MEMORANDUM TO: Mr. Mike Mills, PE  
Division 7 Engineer

SUBJECT: Guilford County; Greensboro Eastern Loop from US 70  
Relocation to SR 2303 (Lawndale Drive);  
WBS No. 38421.1.1; **TIP U-2525B & C.**

Action ID: SAW-2005-21386

**U-2525C Modification Drawings**  
Greensboro Eastern Loop from US 29 north of  
Greensboro to SR 2303 (Lawndale Drive)  
34821.1.1

PERMIT DRAWINGS  
SHEET 2 of 8

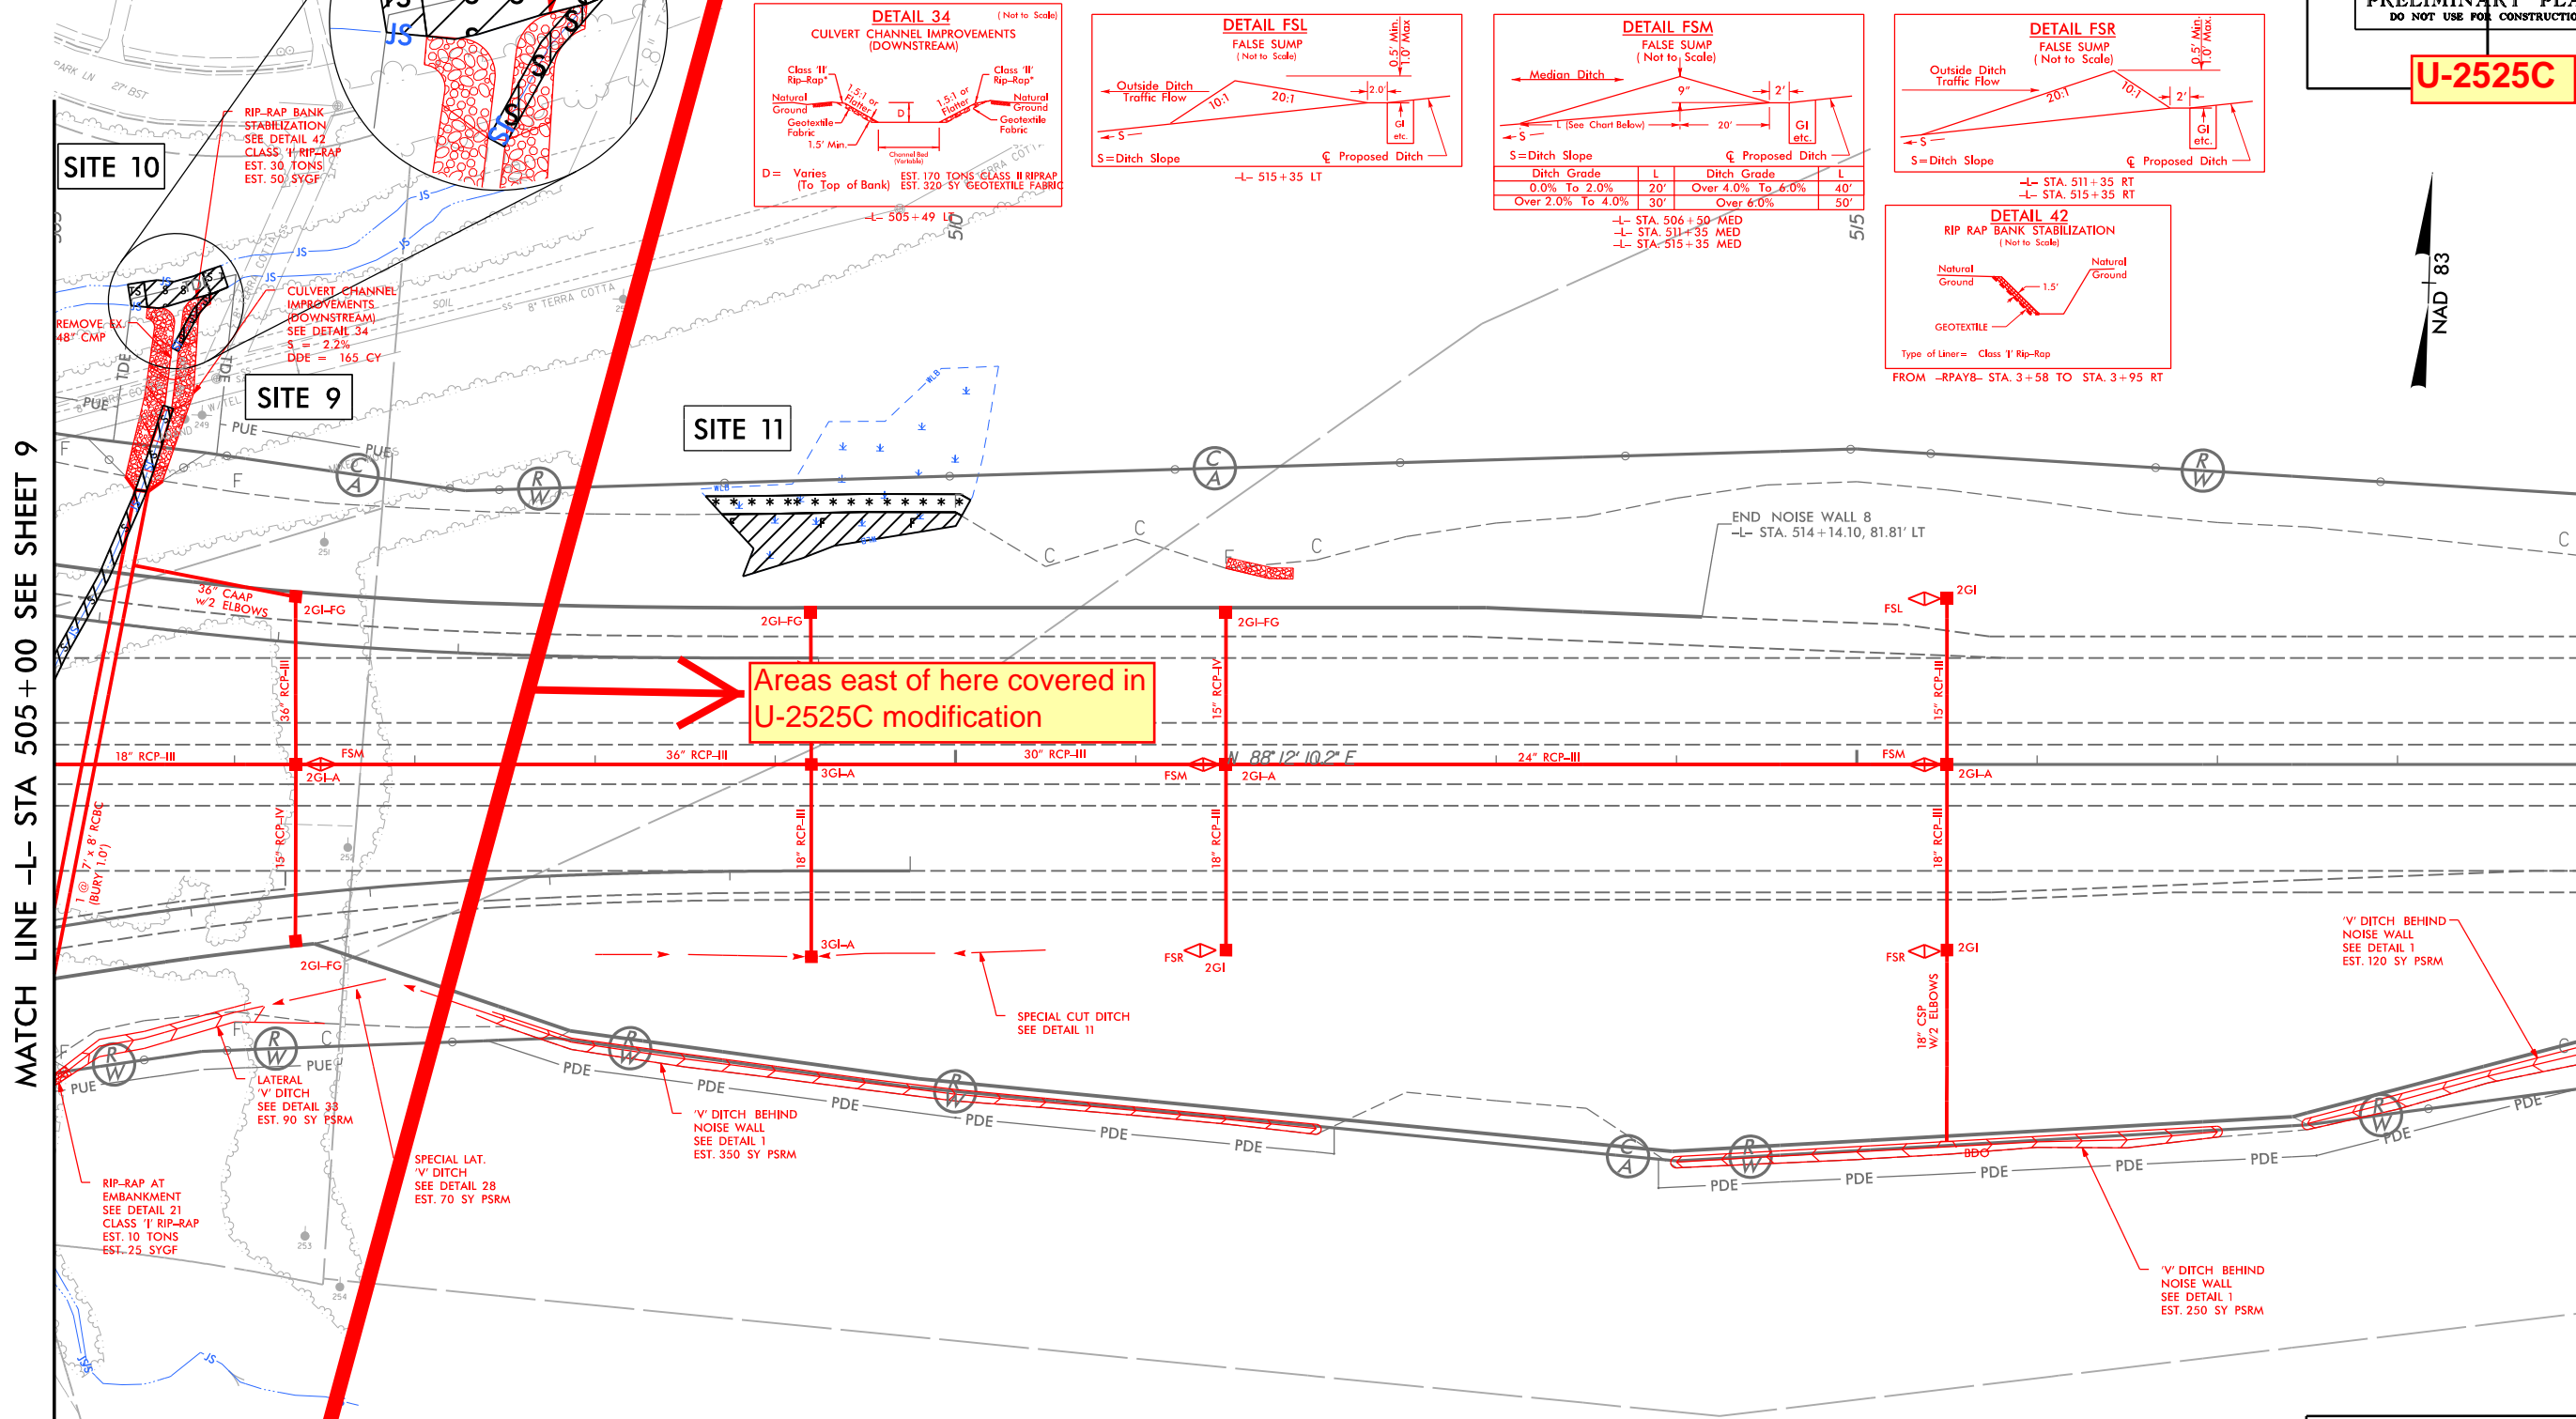
Areas east of here covered in U-2525C modification

RIP-RAP BANK STABILIZATION  
SEE DETAIL 42  
CLASS 'I' RIP-RAP  
EST. 30 TONS  
EST. 50 SYGCF

CULVERT CHANNEL IMPROVEMENTS (DOWNSTREAM)  
SEE DETAIL 34  
S = -2.2%  
DDE = 165 CY

PERMIT DRAWINGS  
SHEET 3 of 8

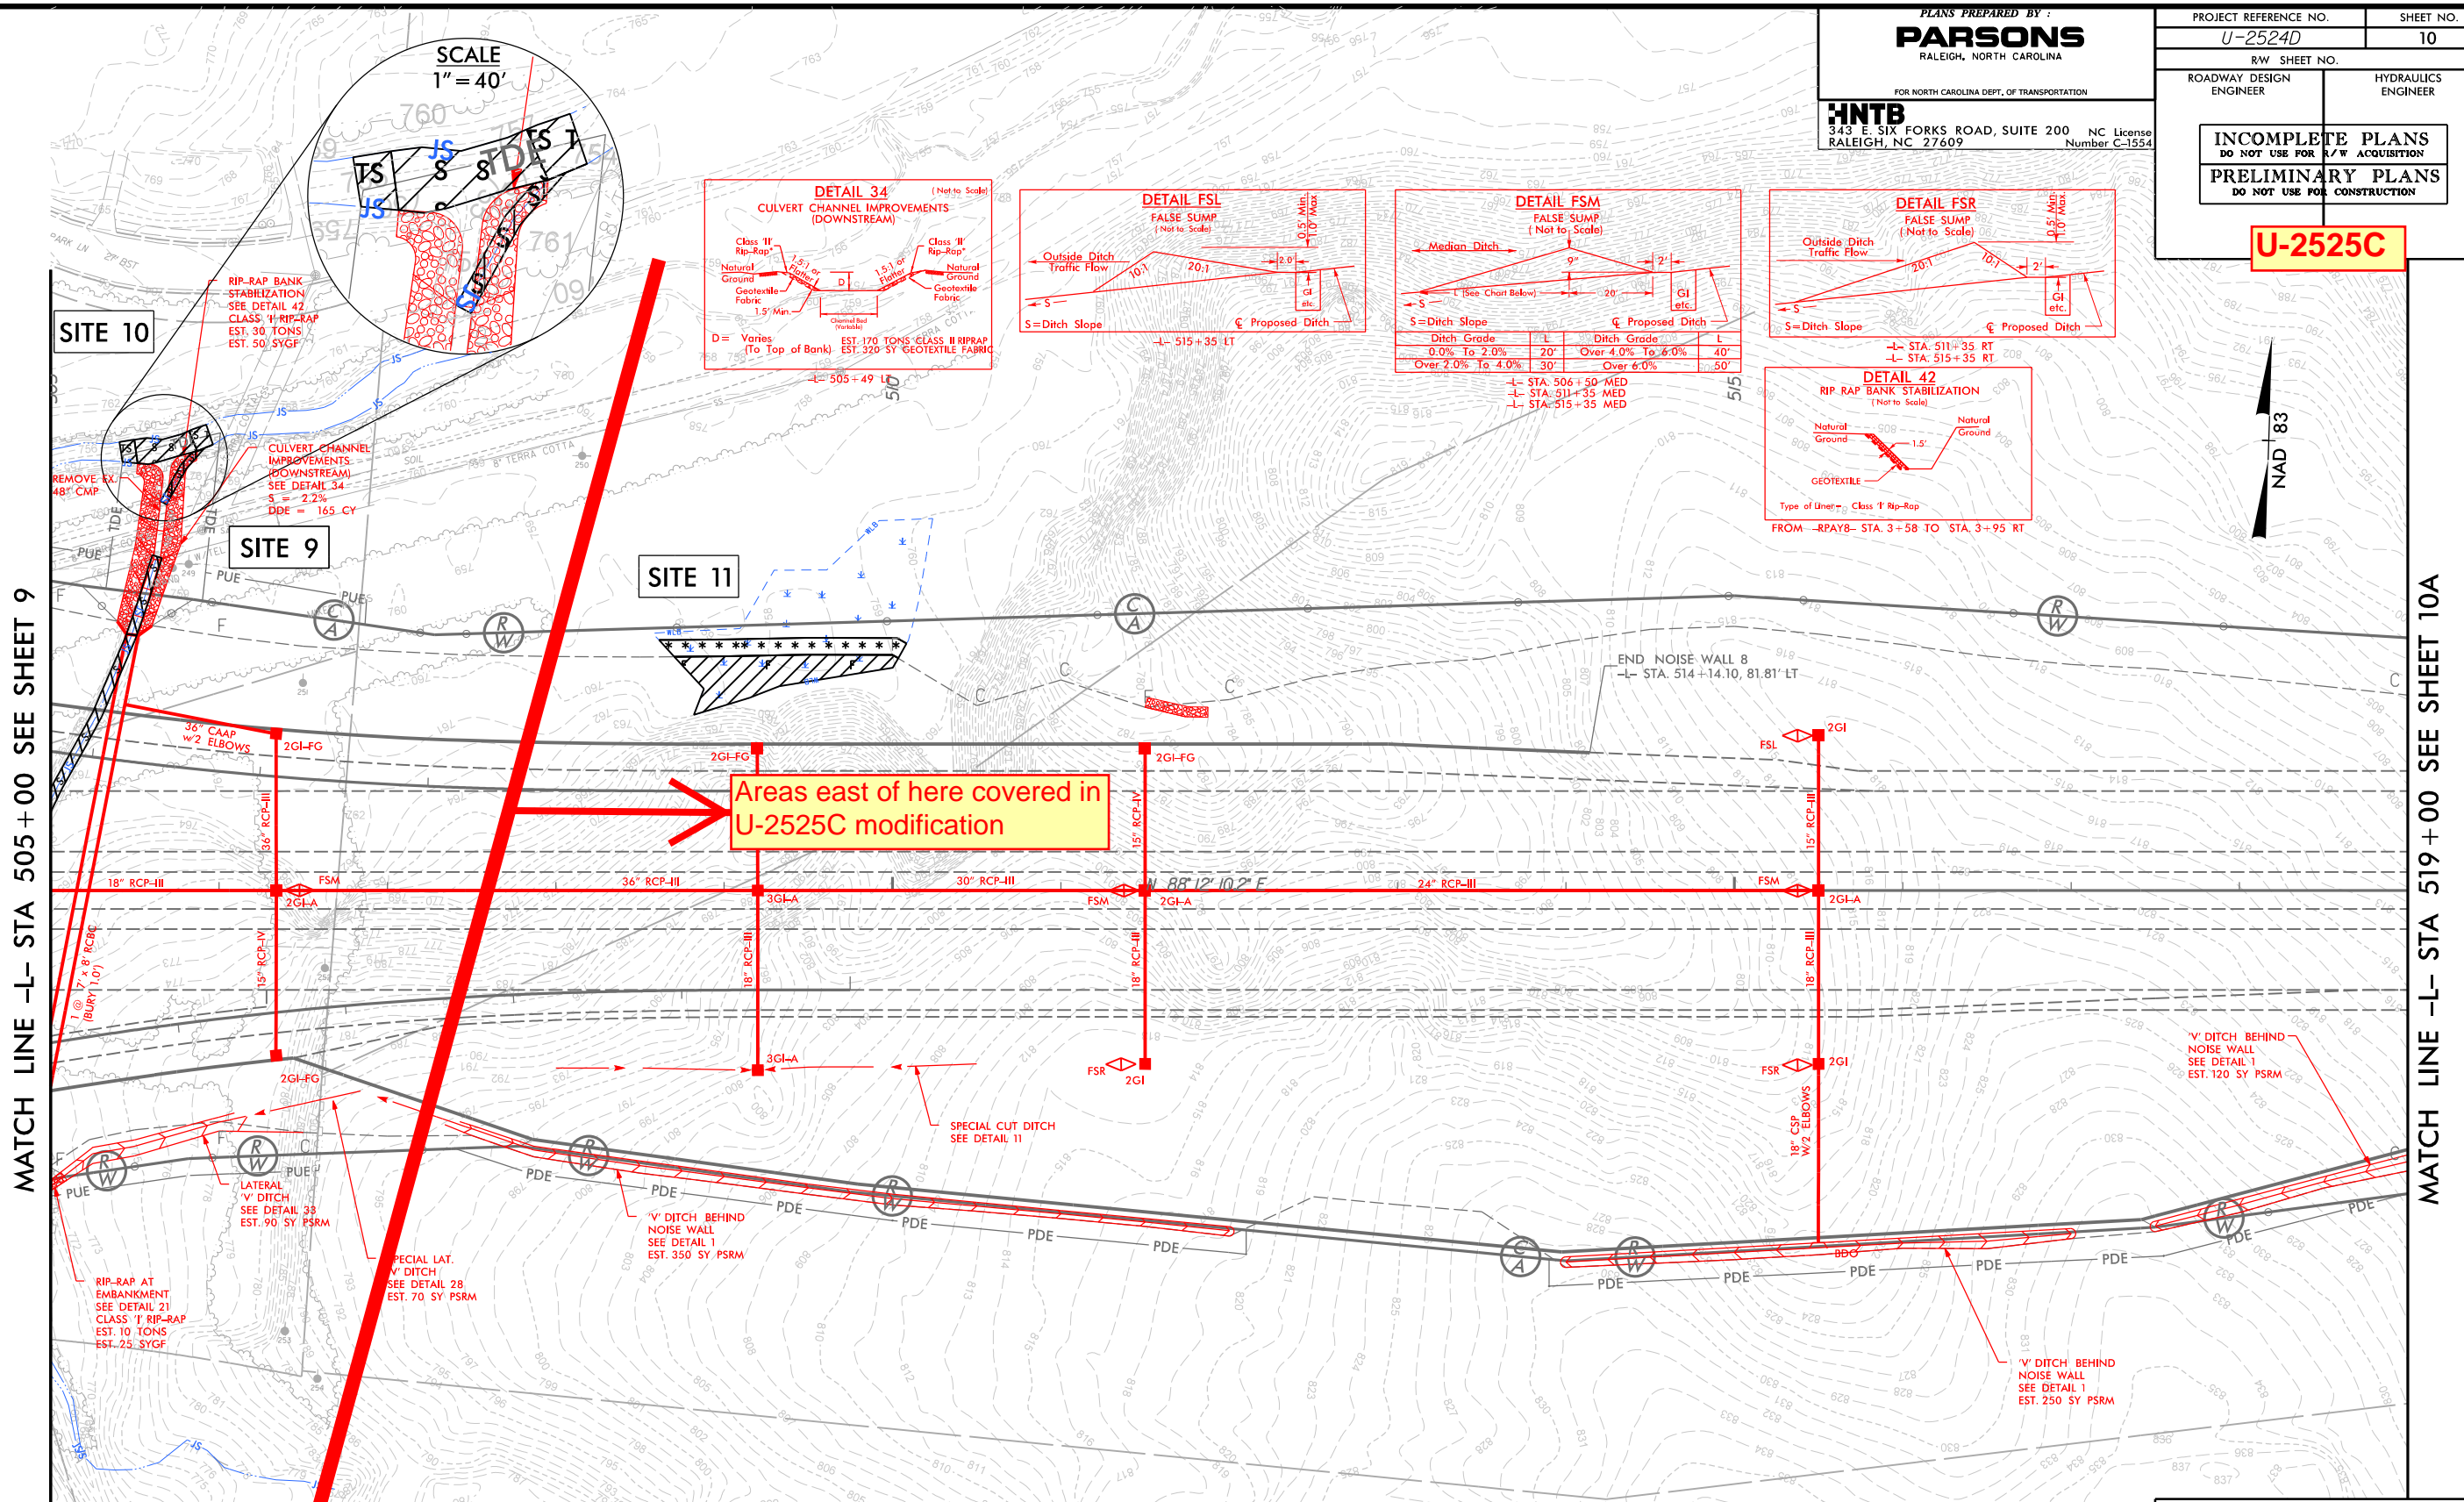
RIP-RAP BANK STABILIZATION  
SEE DETAIL 42  
CLASS 'I' RIP-RAP  
EST. 30 TONS  
EST. 50 SYGF

CULVERT CHANNEL IMPROVEMENTS (DOWNSTREAM)  
SEE DETAIL 34  
S = 2.2%  
DDE = 165 CY

REMOVE EX 48" CMP

Areas east of here covered in U-2525C modification
